SP 2-219-001
SERVICE PROGRAM

Charge air cooler (CAC) pipe and static pipe replacement.

This service program provides information regarding the replacement of the CAC pipe and the static pipe on certain 2016 model year Xpeditor vehicles equipped with ISL engines.

Figure 1

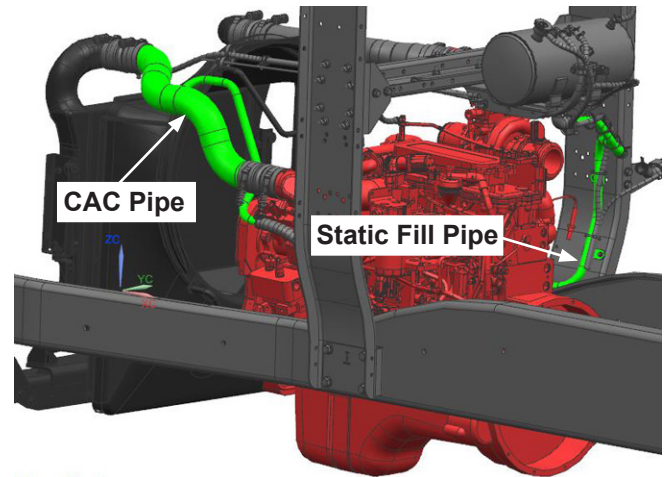
5. After the cooling system is completely drained, close the drain valves.
 6. Remove and discard the CAC pipe by first loosening the T-Bolt clamps and then removing the tension clamp, and set aside for reinstallation (See Figure 1).
 7. Install the new CAC pipe (A2190234-001) and tighten the T-Bolt clamps to 72 in-lb/6 ft-lb of torque. Reinstall the tension clamp (See Figure 1).
 8. Remove the tension clamps from the static fill pipe and set aside for reinstallation (See Figure 1).
- Note:** It may be necessary to loosen the oil fill pipe and the dipstick to be able to extract the static pipe.
9. Remove and discard the static fill pipe (See Figure 1).
 10. Install the new static fill pipe (A2120448-001). Reinstall the tension clamps (See Figure 1).

Note: Tighten the oil fill pipe and the dipstick if loosened in step 8.
